## FIELD INSPECTION REPORT GREENS CREEK MINE

**Inspection Date:** June 27, 2005  
**Report Date:** July 21, 2005  
**Weather:** Fair. Temperatures around 60°F.  
**Inspection Objectives:** Observation of tailings water storage facilities  
**Operator Contact:** Eric Sundberg, Kennecott Greens Creek Mining Co. (KGCMC)  
**State Personnel:** Ed Emswiler, DEC; Charlie Cobb, DNR,  
**Other Personnel:** Tom Zimmer, KGCMC; Keith Everard, Klohn-Crippen  
**Documentation:** Photos were taken and are available for inspection at DNR in Anchorage and DEC in Juneau.

Note: This is a joint report by ADNR and ADEC.

**Figure 8. Site D and Pond D**

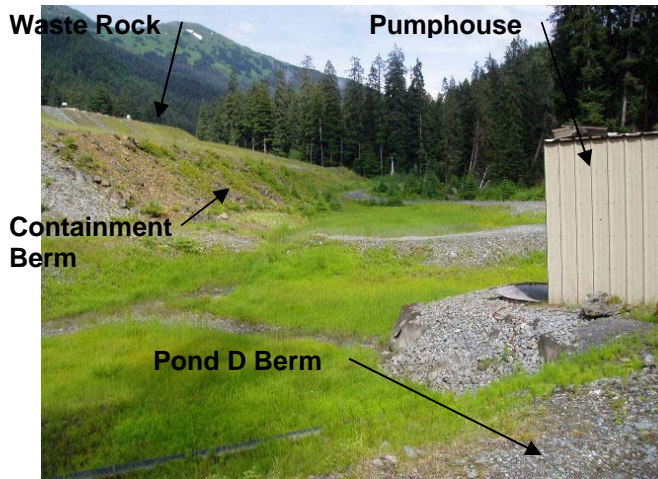
At Site D, placement of native glacial till excavated from the mill during site development is overlain by waste rock, as seen in Figure 8. Recent investigative field work and data analysis associated with hydrology, geochemistry and geotechnical stability suggest that there may be long term advantages to relocating the production rock placed at Site D. Field work and data analysis is continuing to identify potential risks and benefits with either leaving the site at the current location or moving the material elsewhere. We observed red staining of the rock in the outer buttress that is most likely due to lichen growth, as seen in Figure 9.

The remediation plan for the Pond D berm will result in its being removed within a few years, following completion of other priorities, such as a pumped water return system from Pond C. Plans include reconstructing the berm with inert material; a possible source is material recovered from the continuing development of the upslope of Site 23.
